FIREFOX

Amplifone Raster Modification

4. Deflection Board

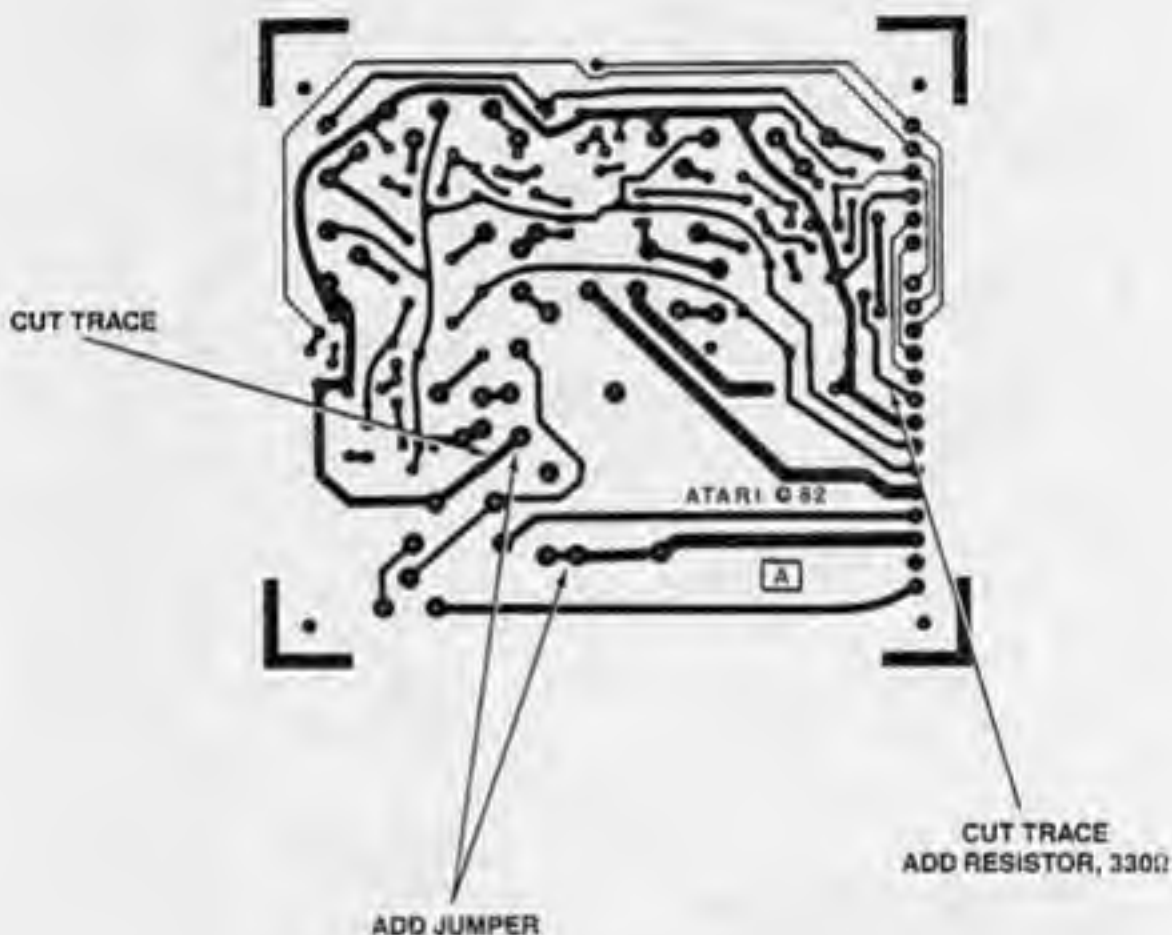
Install a 1N751A zener diode (5.1 V) to the vertical sync input, anode to ground, as follows:

- Locate the first pad connected to J1 pin 5 on the trace or circuit side of the board. Note: PLL board is installed in place of J1.
- Locate the pad going to ground near J1 pin 6, between pin 6 and R10.
- Install the zener diode (anode to ground) between these two pads on the circuit side of the PCB.

5. a. Remove C5 (0.1 μ F) axial cap.
b. Install a 0.22 μ F (25 V) axial cap between the cathode and gate of Q4 (MC6101), soldering one lead of the cap to the cathode pad (square pad) of Q4 and the other lead to the pad of C5 connected to the gate of Q4. Install the cap on the circuit side of the PCB.
6. Route the high-voltage anode lead away from the deflection board, and secure it with a wire tie wrap.

Neck PCB Assembly

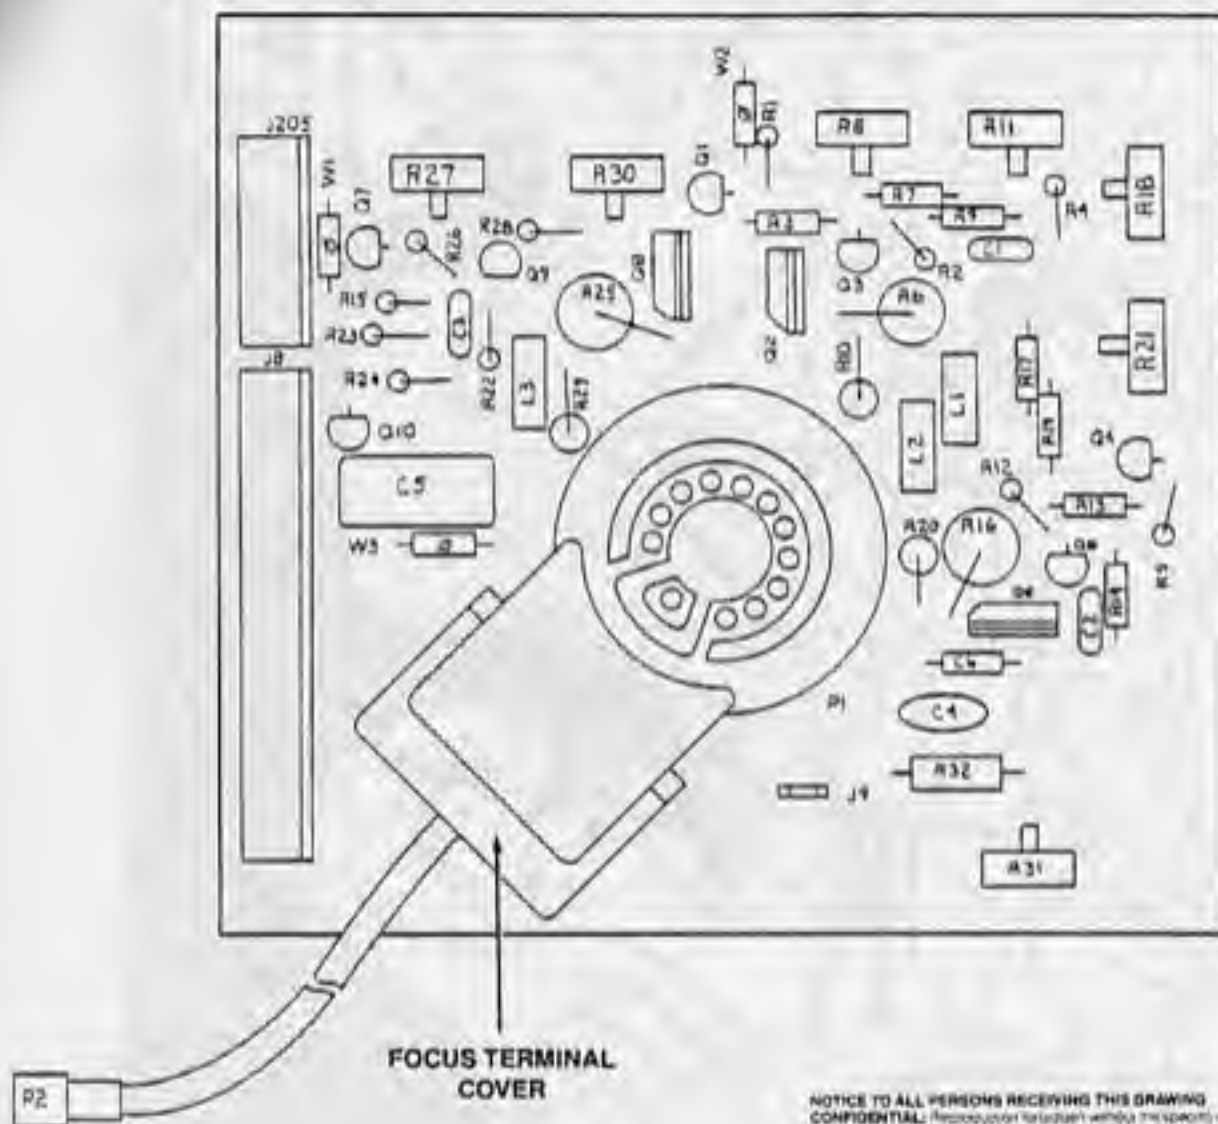
Cut the trace between the pad at CRT socket pin 5 and the nearest pad. Install an insulated jumper (1000 volts or better insulation) between pad at CRT socket pin 5 and either of the pads at spade lug J9. Use a number 20 wire.

3. Remove the focus terminal cover from the CRT socket and unsolder the focus lead from the terminal. Solder a 22 meg-ohm, $\pm 5\%$, $\frac{1}{4}$ watt carbon-composition resistor to the terminal with the end flush with the terminal and resistor parallel to the board. Solder the focus lead flush with the other end of the resistor, and trim the resistor lead. Route the focus lead back to the exit groove, and replace the cover.
